# HISTORIC AND DESIGN REVIEW COMMISSION

**HDRC CASE NO:** 2018-261  
**ADDRESS:** 917 HAYS ST  
**LEGAL DESCRIPTION:** NCB 1654 BLK B LOT 13  
**ZONING:** R-5 H  
**CITY COUNCIL DIST.:** 2  
**DISTRICT:** Dignowity Hill Historic District  
**APPLICANT:** Bob King/Alamo Construction & Demolition  
**OWNER:** Alan Bowdin  
**TYPE OF WORK:** Chimney removal, window replacement  
**APPLICATION RECEIVED:** May 11, 2018  
**60-DAY REVIEW:** July 10, 2018  
**REQUEST:**

Existing  
SCALE: 1/4" = 1'-0"

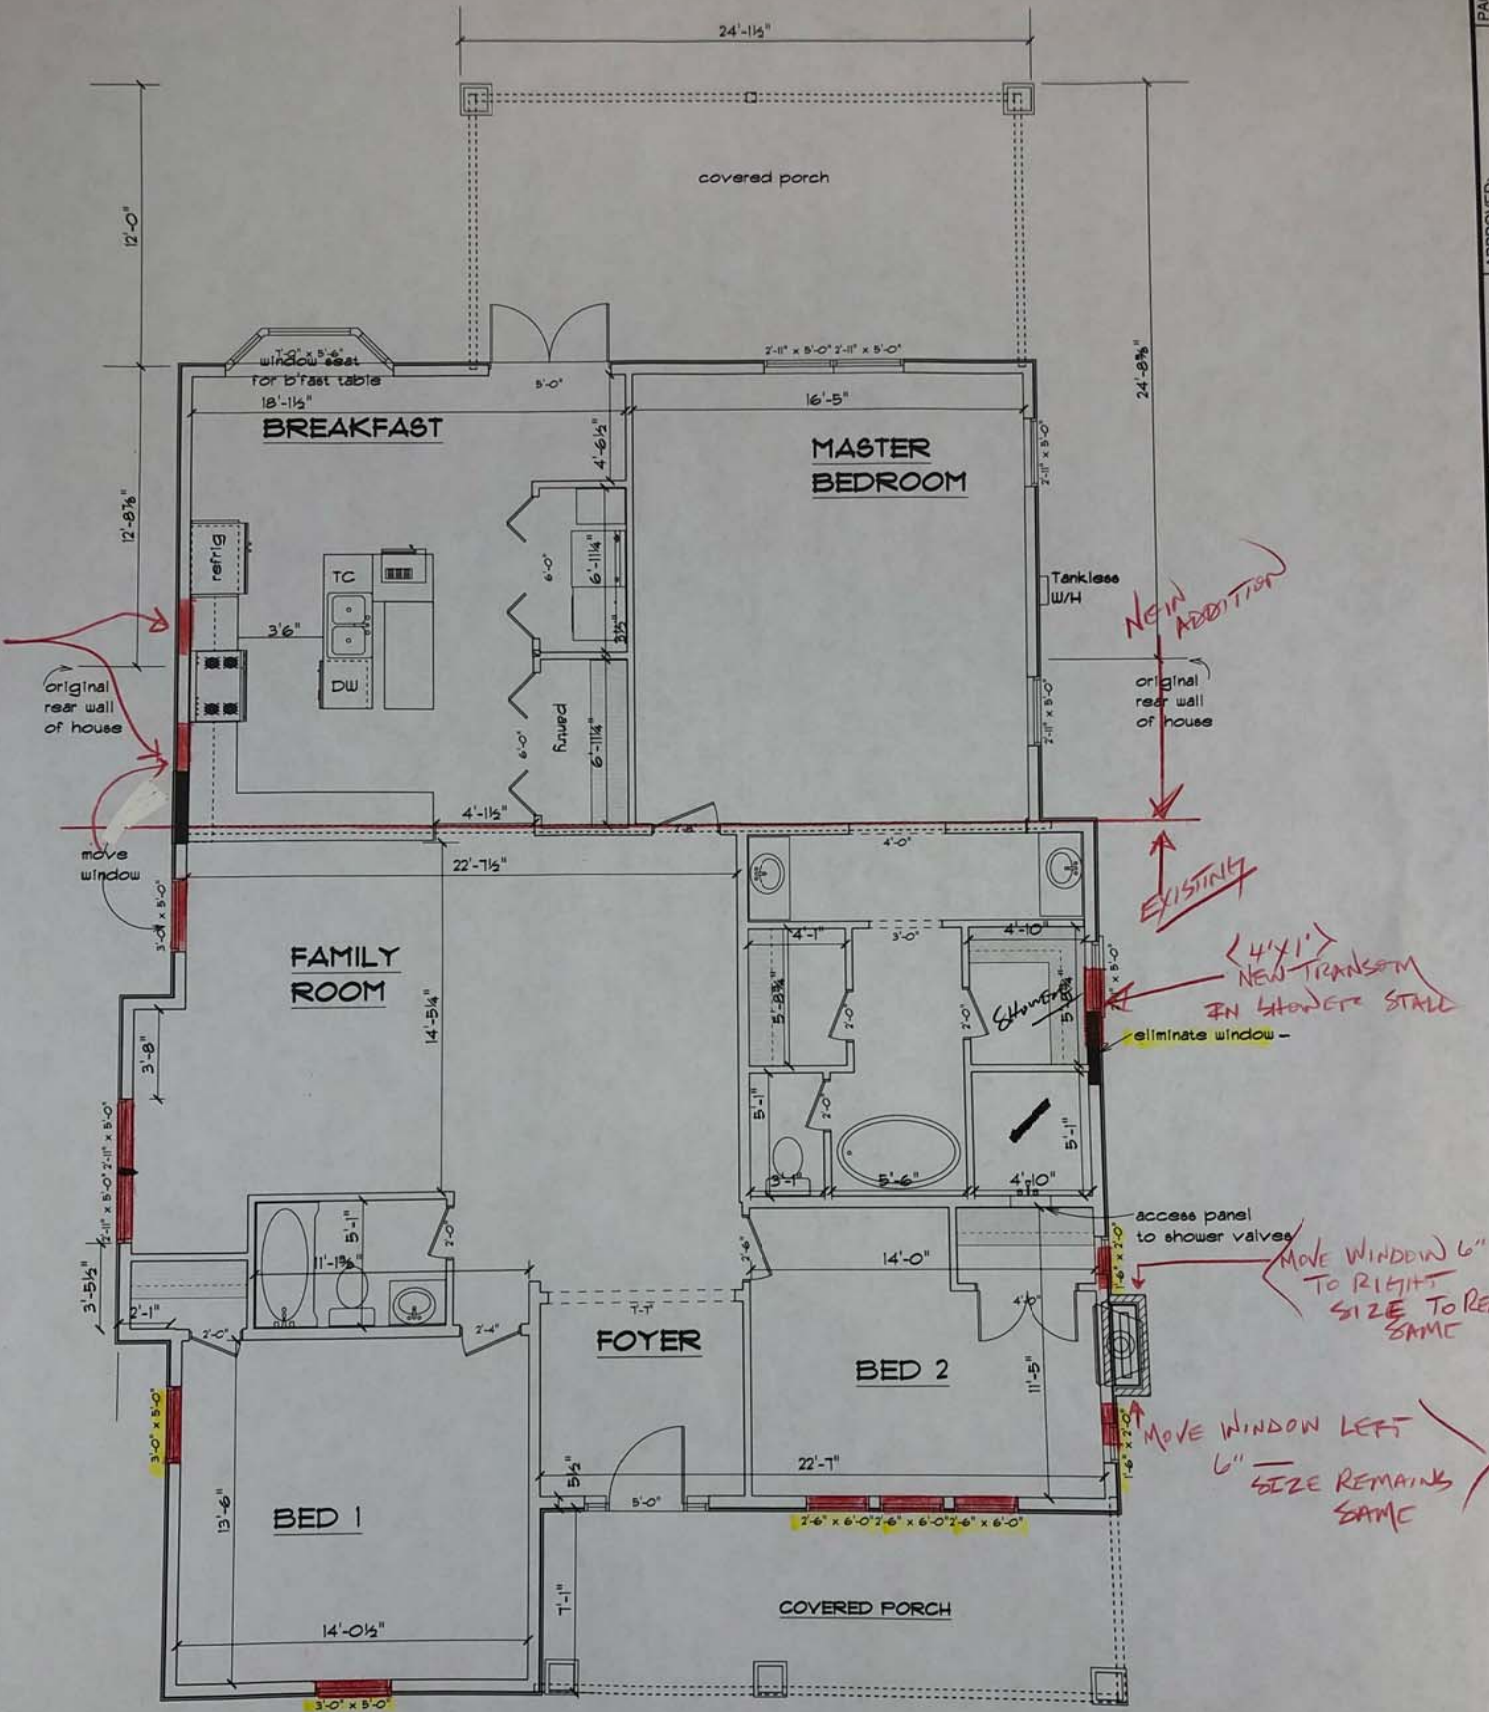
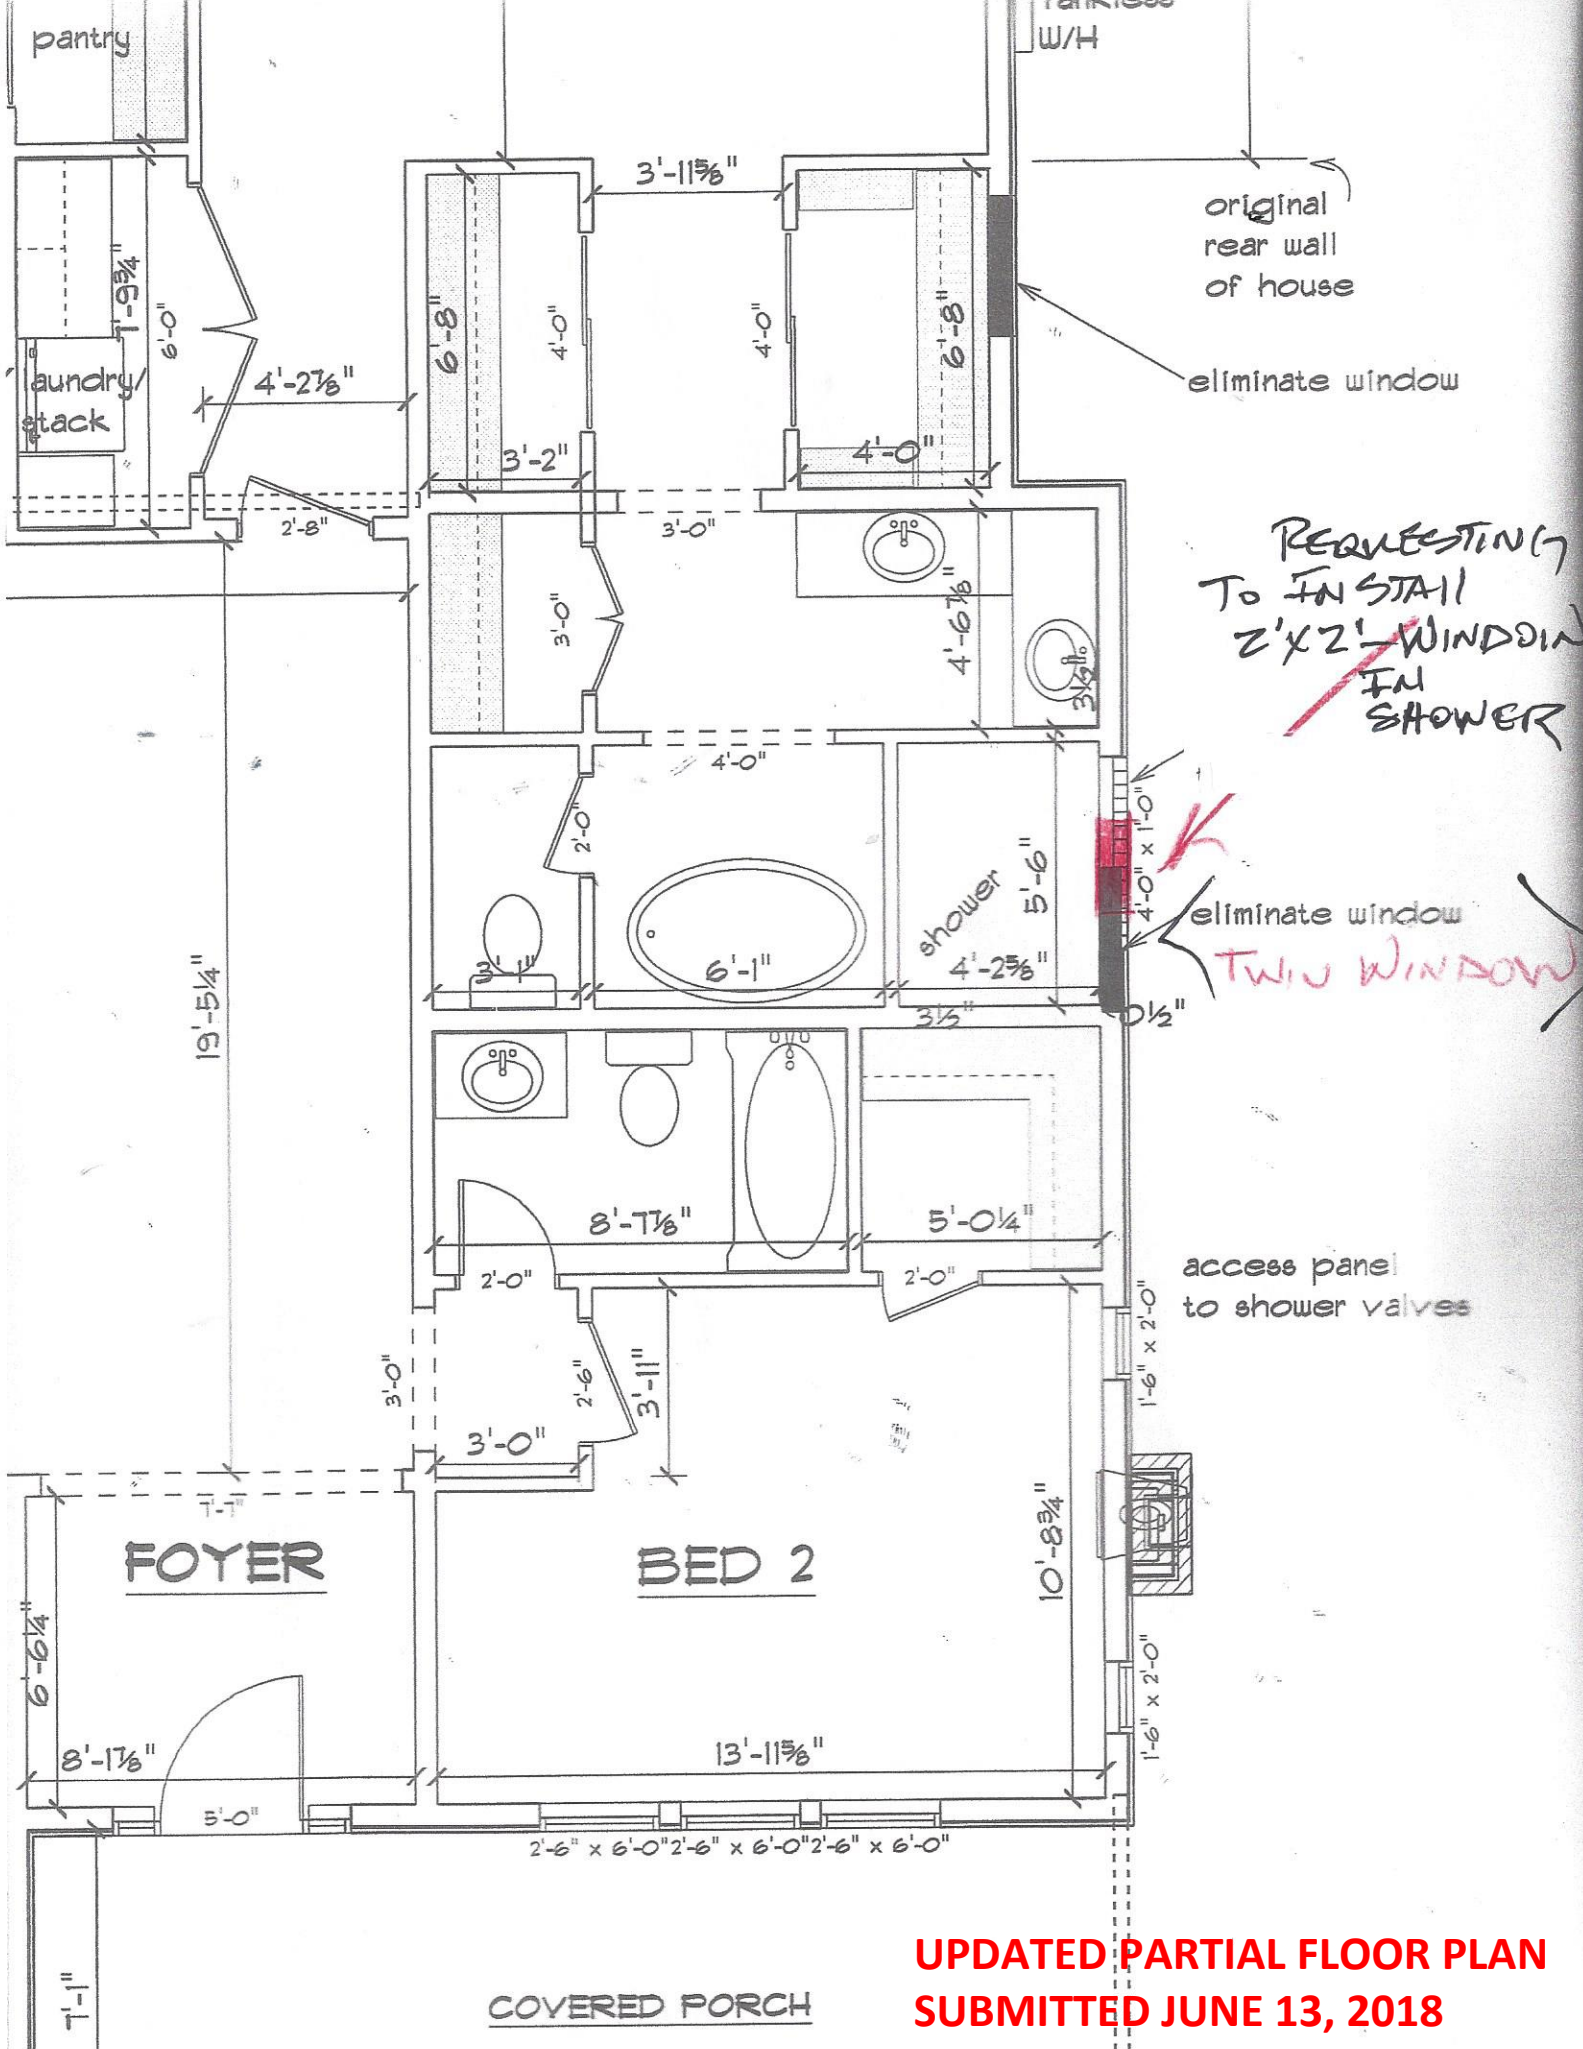
- g. **WINDOW MODIFICATIONS** – The applicant has proposed to relocate two existing one over one wood windows on the west façade. The windows are located on either side of a brick fireplace. The applicant has requested to move the windows approximately 6 to 12 inches higher and a few inches closer to the fireplace. The applicant noted on a site visit that the relocation is required due to the construction of an interior wall that will intersect one of the windows, which has already been framed out. The second window is to be relocated to match the first. Additionally, the applicant has proposed to eliminate two windows from the east façade and install a new 2x2' square window. A different applicant made a similar request at the December 6, 2017, HDRC hearing, but withdrew the item for consideration. According to the Historic Design Guidelines, the location of historic door and window openings should be avoided. The existing openings are original to the historic structure and are visible from the public right-of-way. Staff does not find the removal consistent with the Guidelines.

Items 4, and 5, Staff does not recommend approval of the window relocation and replacement based on findings d and g. Staff recommends that the openings be retained and that the existing windows be repaired.
